Consultation on the Old Oak Common West SPD- TfL comments

Appendix A: Specific suggested edits and comments from TfL on the draft Old Oak West SPD

Fig 11.18 (p109)-

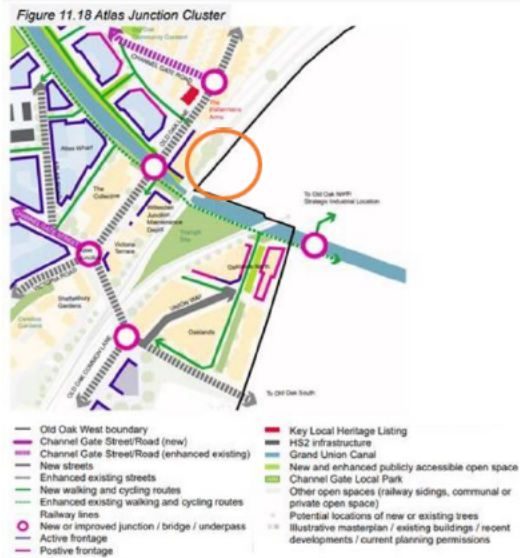
Some illustrative development is shown north of the canal/ east of Old Oak Lane for mixed use development, 6-12 storeys in height within the next 6-20 years. This appears to be on part of the Willesden Southwest siding lands that we are investigating for WLO train stabling and a new facility building (see image below). These sidings are very likely to be needed for this future rail use and so cannot be assumed to be available for development at this time. With further design work there may be options to develop over the sidings if this can be shown to be viable, but there would need to be sufficient space for train storage and potential ancillary infrastructure such as the facility building and a rebuilt bridge over the canal.
